City of Fredericksburg

Historic Review Board Meeting Agenda
Tuesday, December 10, 2024 ~ 5:30 PM
New City Hall at East Campus
2818 E. U.S. Hwy. 290
Fredericksburg, Texas 78624

**HISTORIC REVIEW BOARD
November 12, 2024
5:30 PM**

FLOOR PLAN

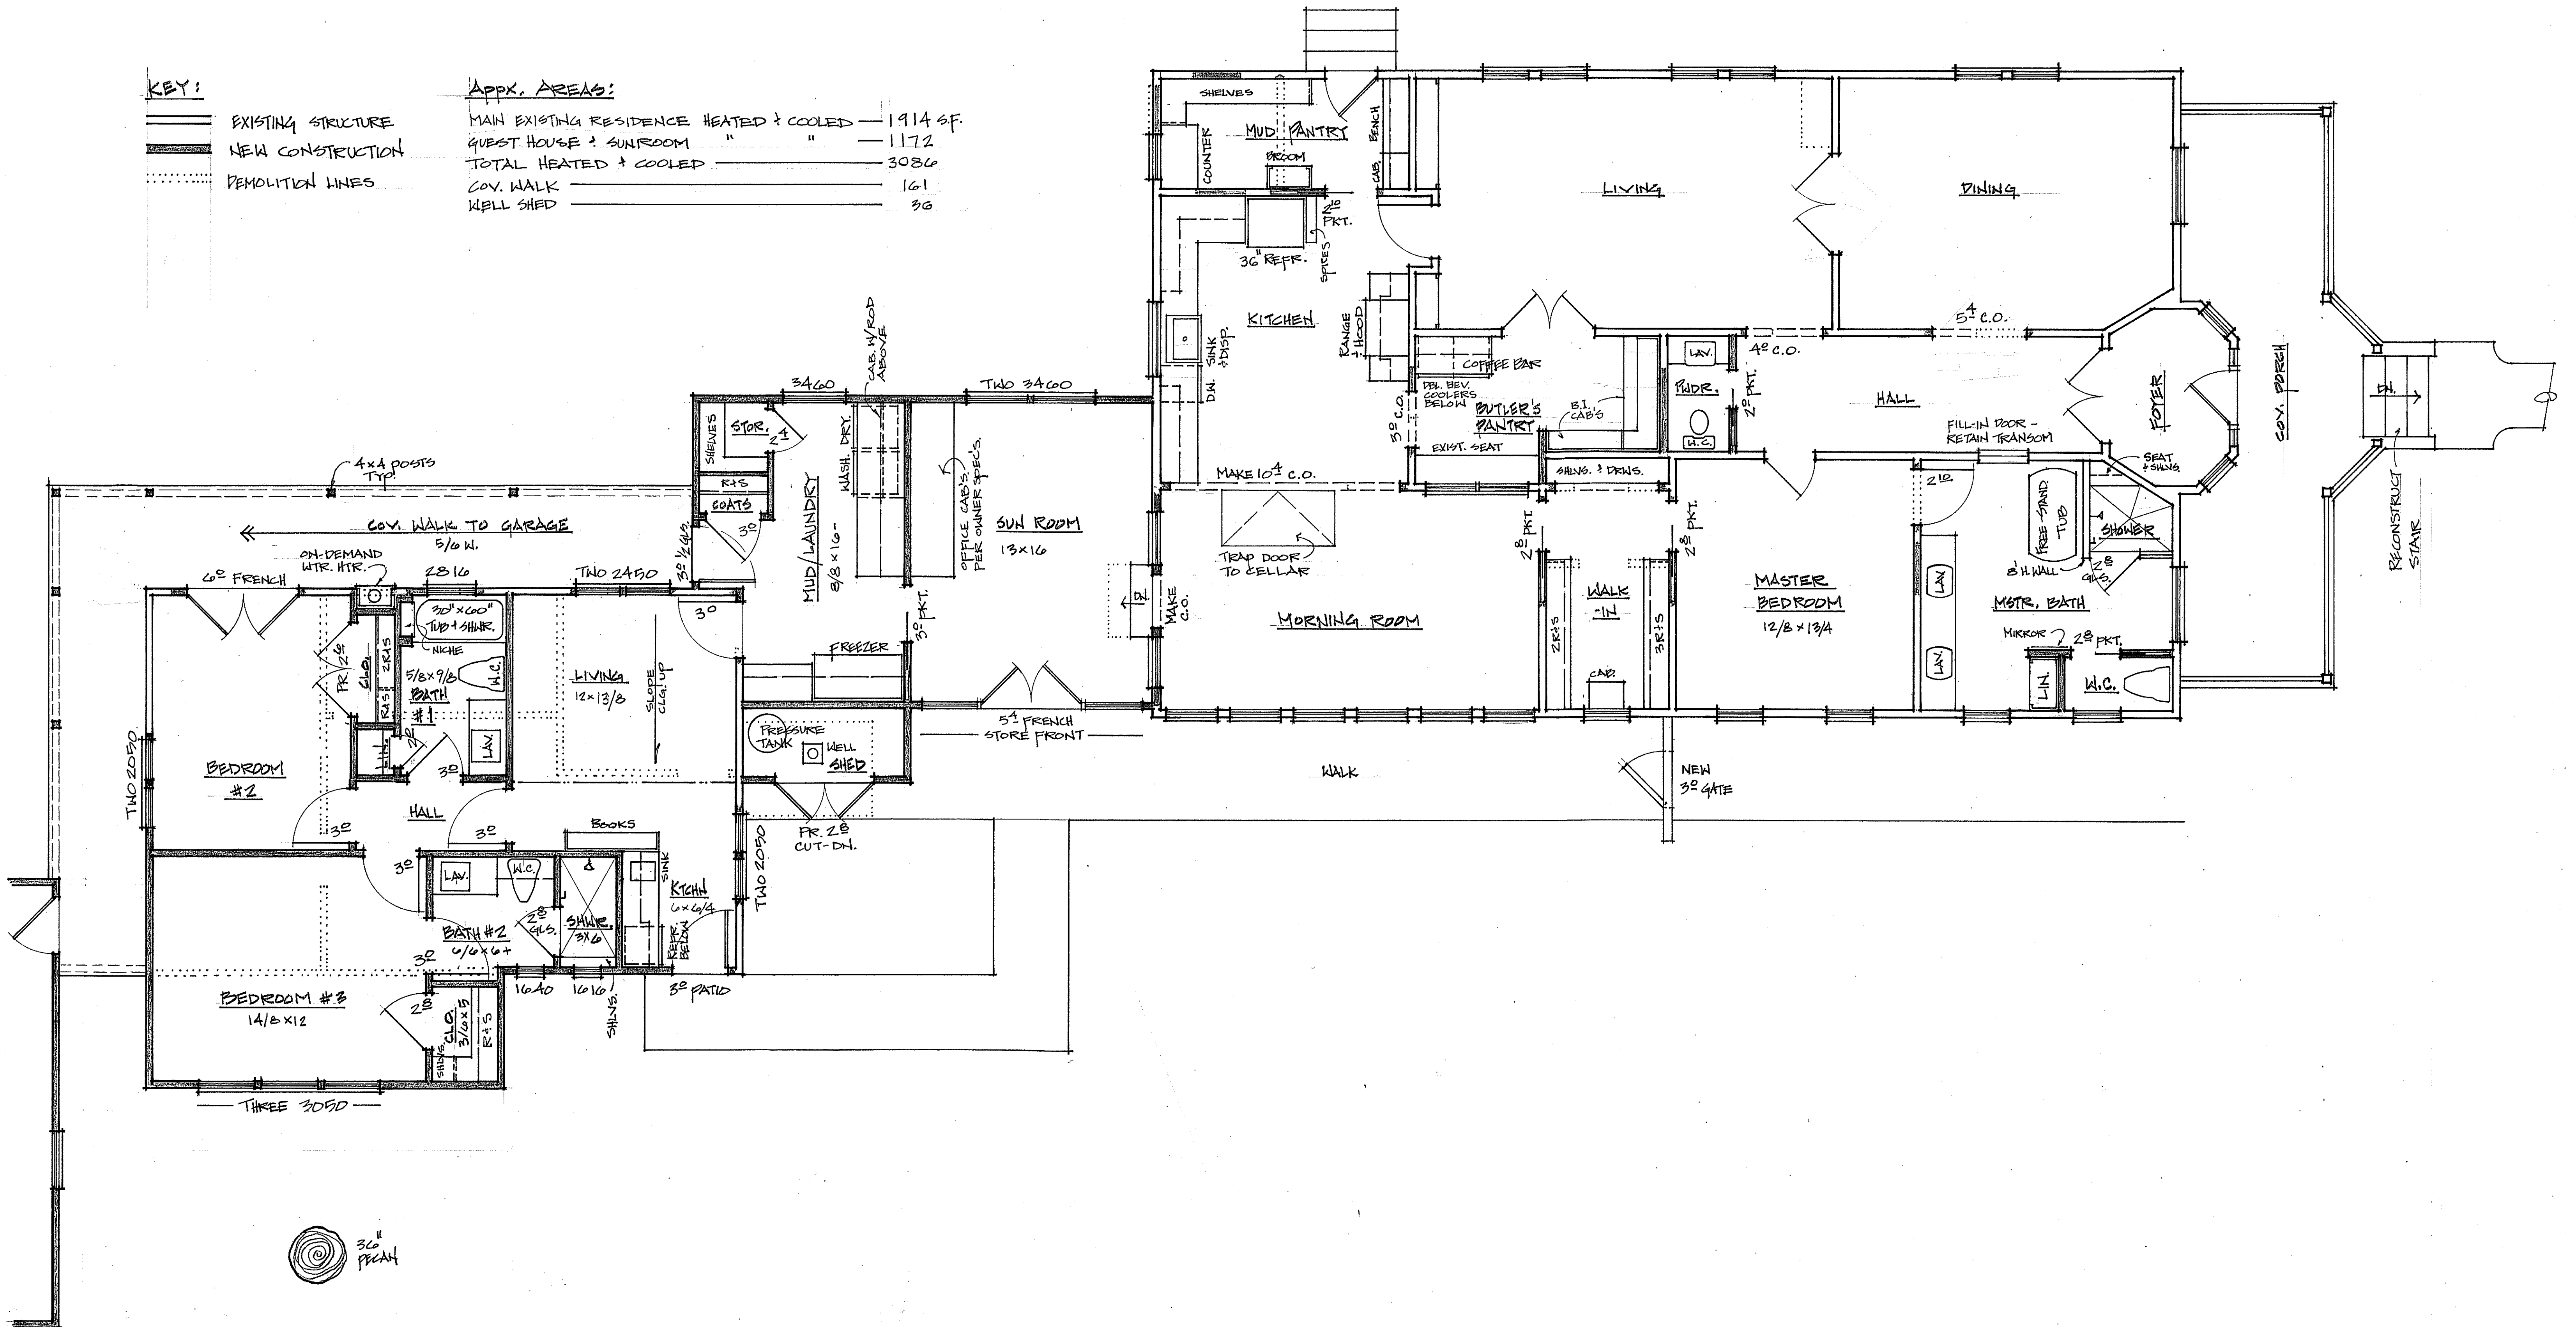
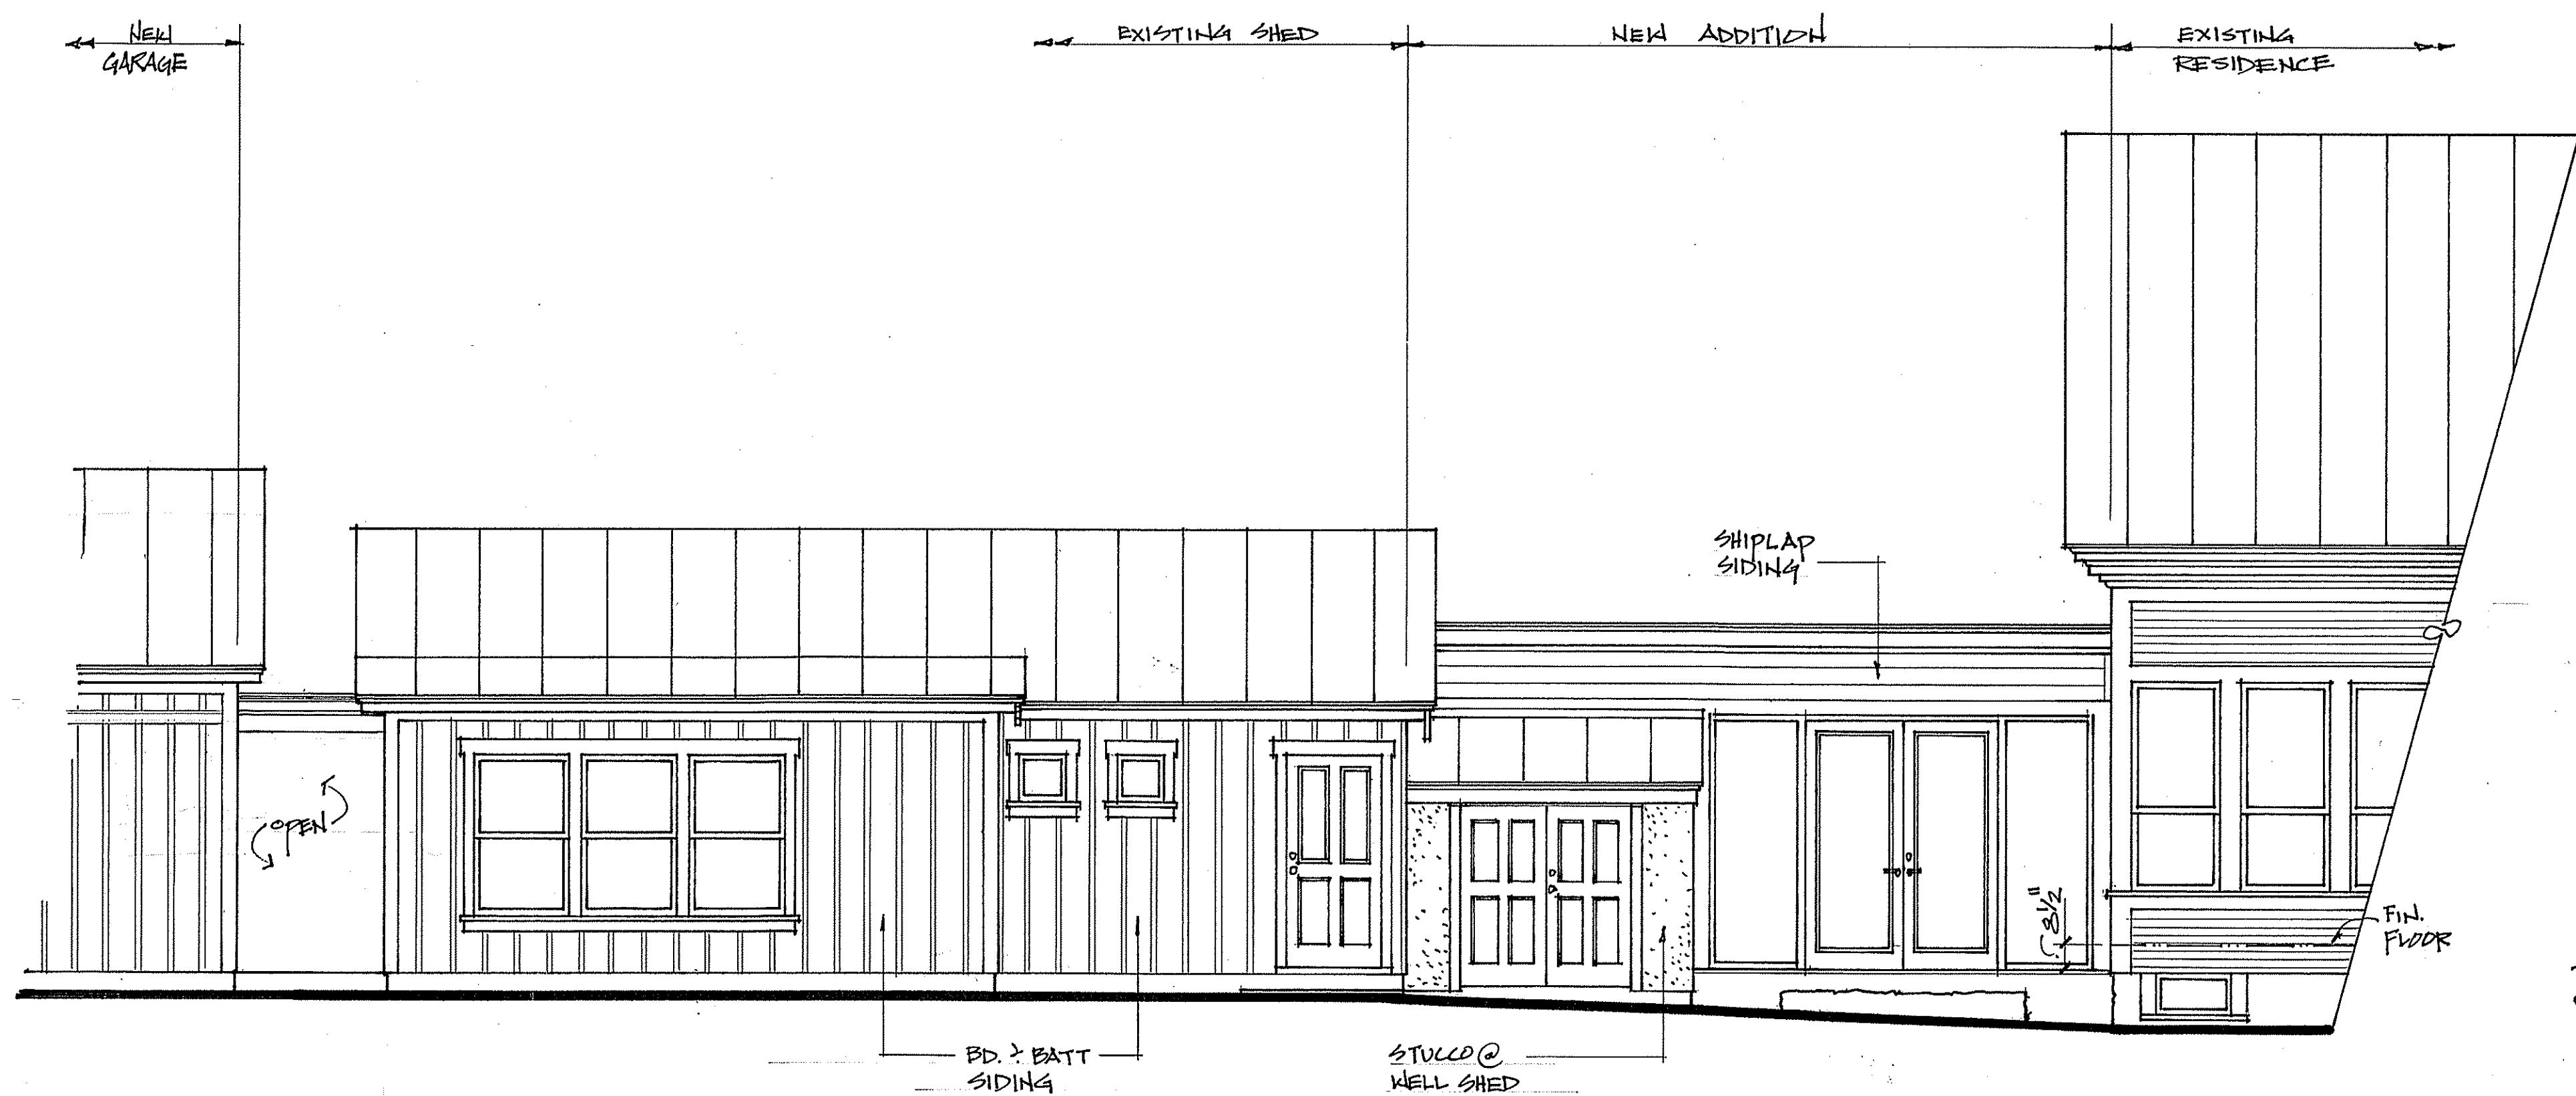
The proposed re-rating of the shed from High to Low would be required to allow for demolition. The information provided by the applicant indicates that the building has deteriorated beyond repair and it has lost its value. In addition, the planned new construction would be a positive addition for the property and would promote the goals of the Historic Preservation Ordinance Sec. 23-63. Staff was able to confirm this information through a site visit with the applicant, designer and contractor on November 20, 2024.

1. Re-rate shed from High to Low
 2. Demolition of shed
 3. Construct a 1,172 sq ft addition
-
-

NEW BARN AT
HISTORIC KLIER HOUSE
410 S. MILAM ST
Fredericksburg, TX 78624

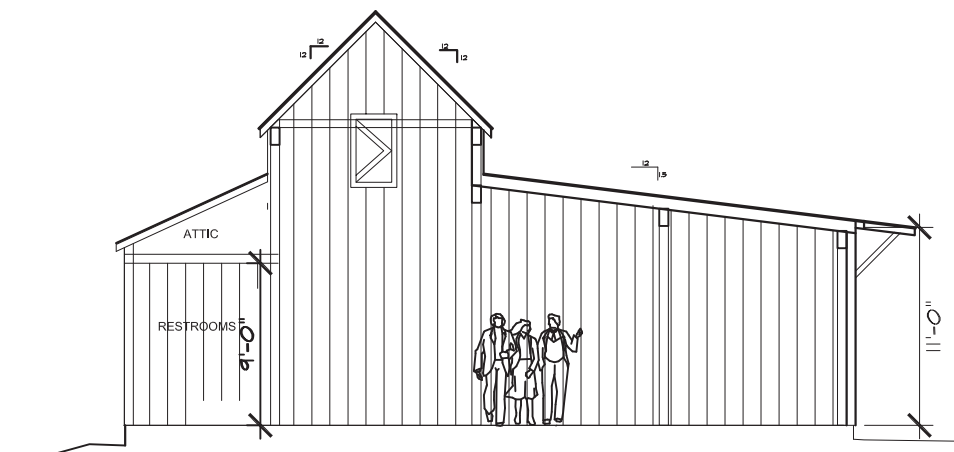
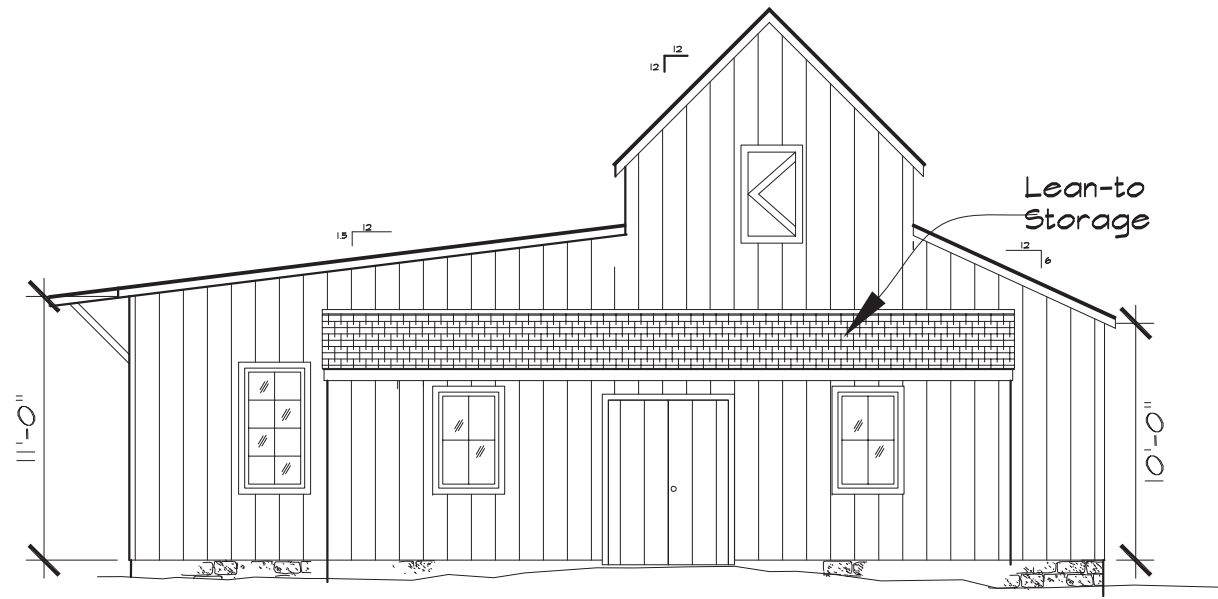
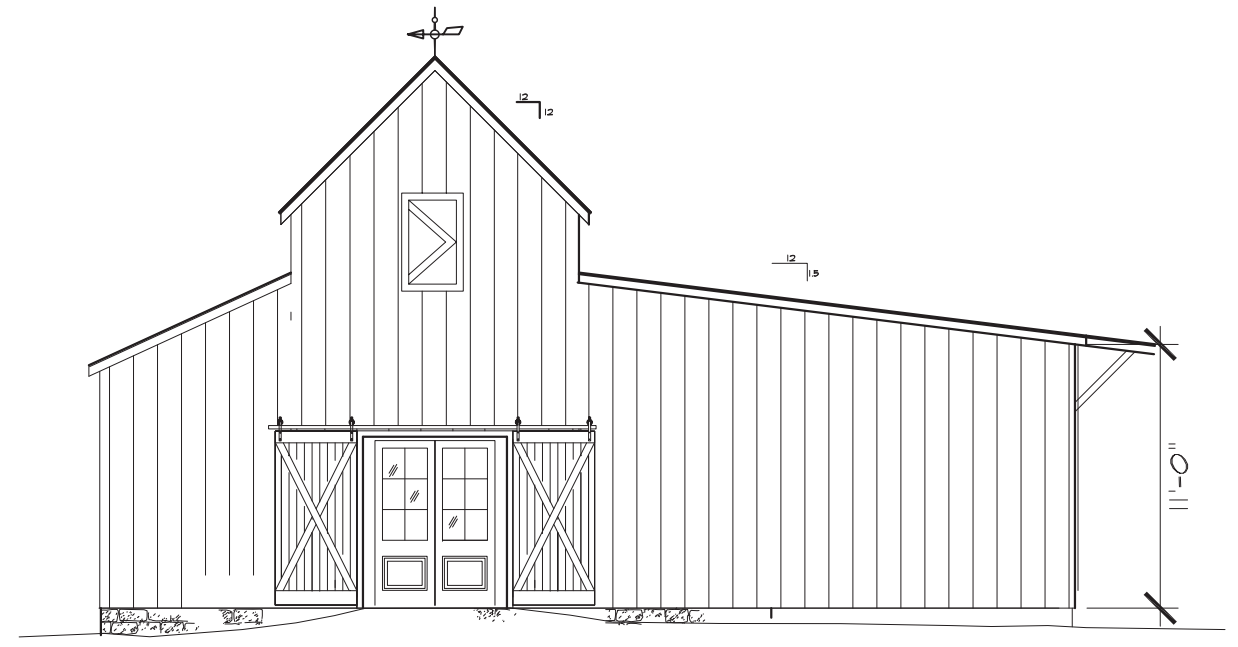
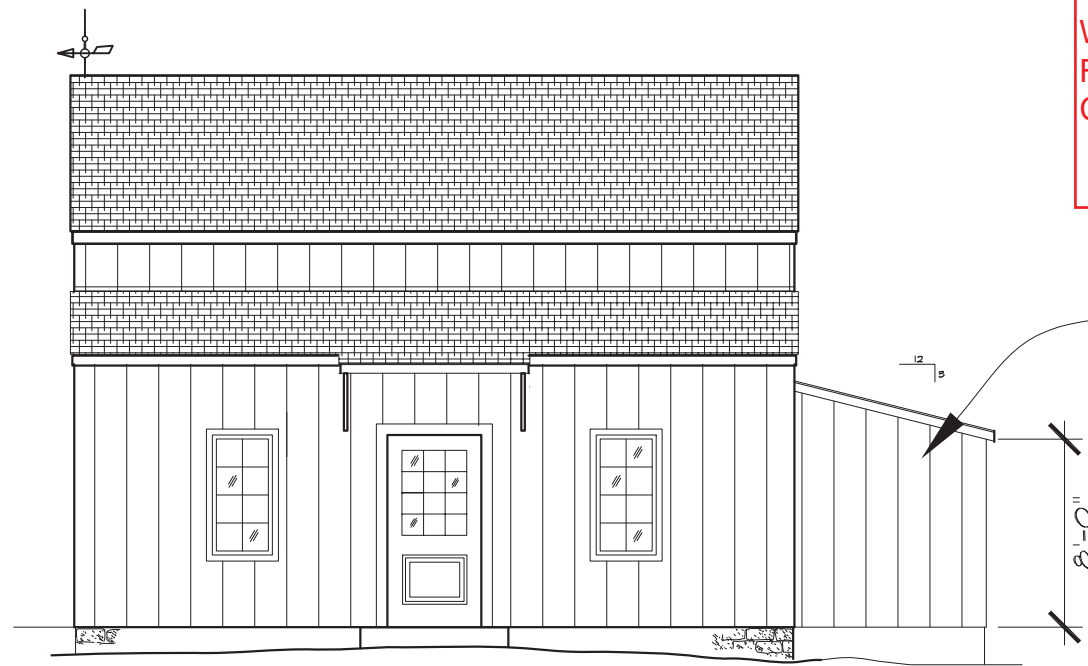
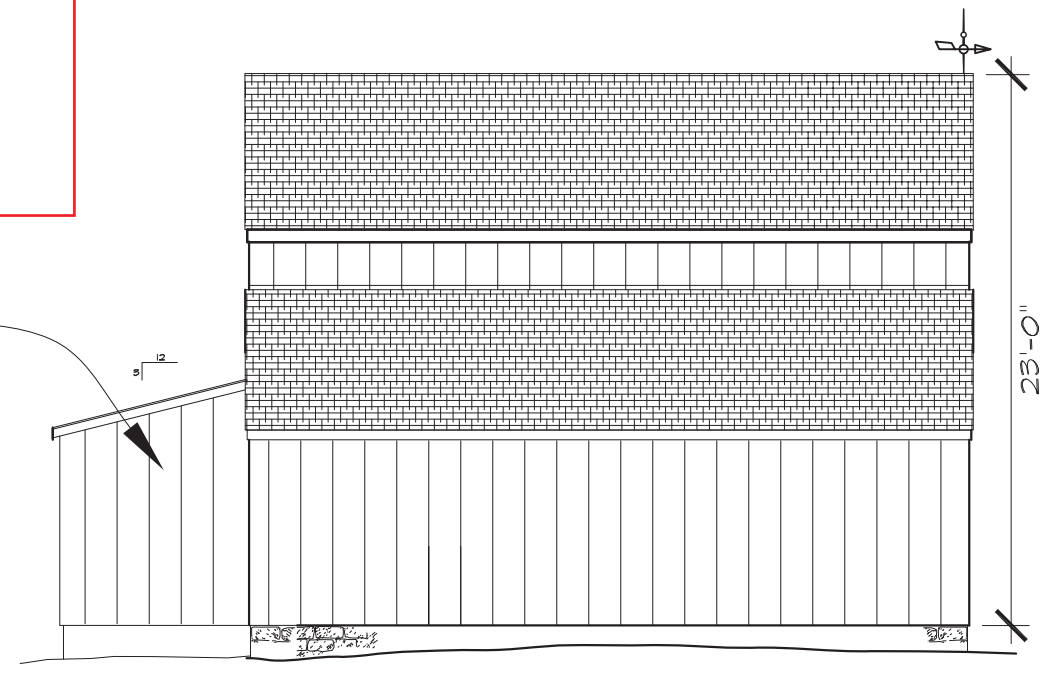
The proposed new barn is not a re-creation of the historic barn, but rather a modern interpretation using traditional materials to create a modern use. The dimensions have been increased to make them usable spaces that are not agricultural. Staff commends the designer and owner for using authentic, reclaimed materials where appropriate and traditional designed windows and doors in a contemporary way. The building will be able to show the agricultural history of the property while being used in a new way for a modern audience. Staff recommends approval.
